19/13-98A Bridge on Rt 118 from
Mateney Hill Rd to Marc train station
(Germantown Historic District)

SUBJECT: Historic Area Work Permit

HISTORIC PRESERVATION COMMISSION STAFF REPORT

RELOCATED MD ROUTE 118 - PHASE III
 PEDESTRIAN BRIDGE OVER CSX
 RAILROAD

2 ELEVATION - TYPICAL ORNAMENTAL PICKET FENCE
SCALE: 1/4" = 1'-0"

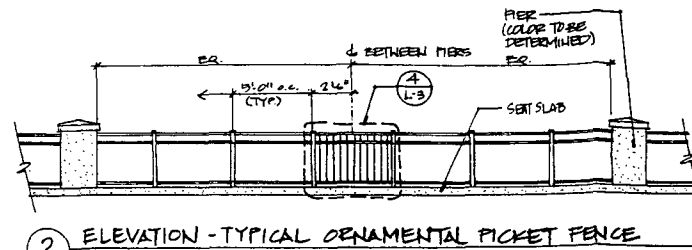
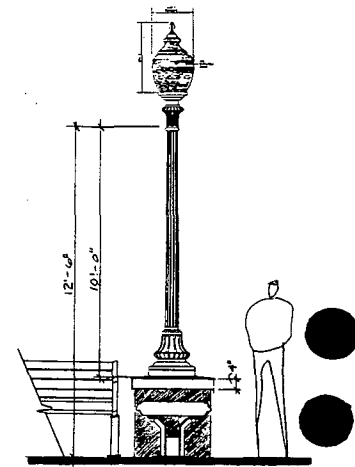
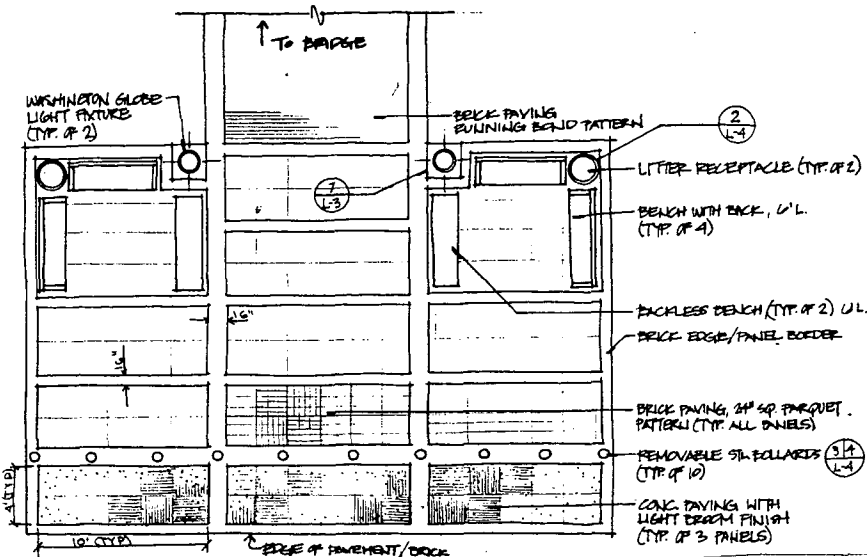
1) bridge railing to be of iron, ie. not of aluminum.

The use of vinyl clad aluminum for the railings should also be discussed with the applicant if the use of cast iron or wrought iron is feasible. It is staff's understanding that maintenance and safety issues led to the present choice of material.

1. The railings on the bridge should not be vinyl clad aluminum. We suggest that they be wrought iron painted black. If this is not affordable, then cast iron painted black would be acceptable. - condition

3 REMOVABLE STEEL BOLLARD
N.T.S.

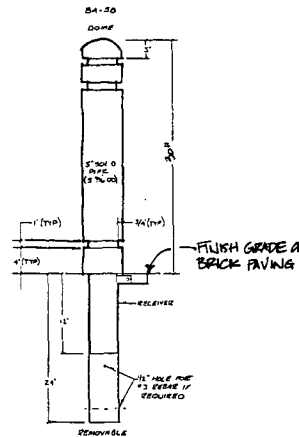
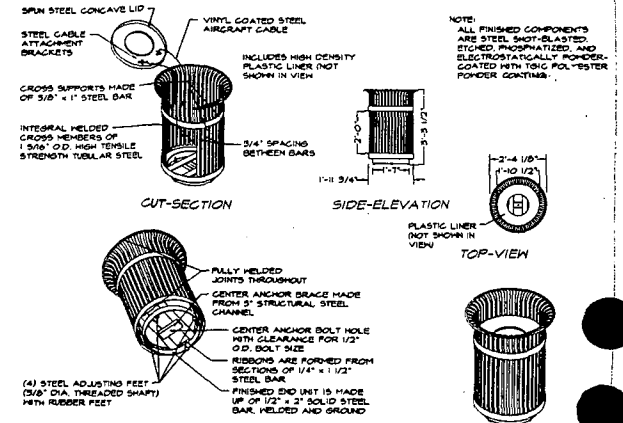
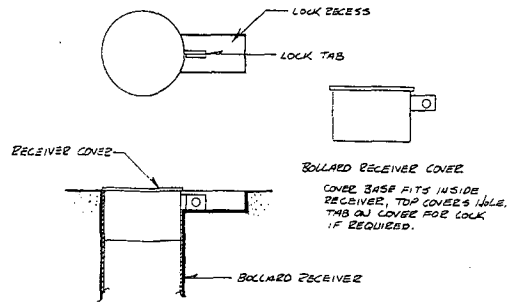
1. The bollards be in the traditional inverted cannon design.
2. The specific sign design and location is to be reviewed as a separate HAWP, or a later revision of this HAWP.

- ✓ 2. The parapet veneer should resemble the native quartzite--not granite or yellow stone. - cement simple treatment
3. The bollards should resemble inverted cannons. - condition
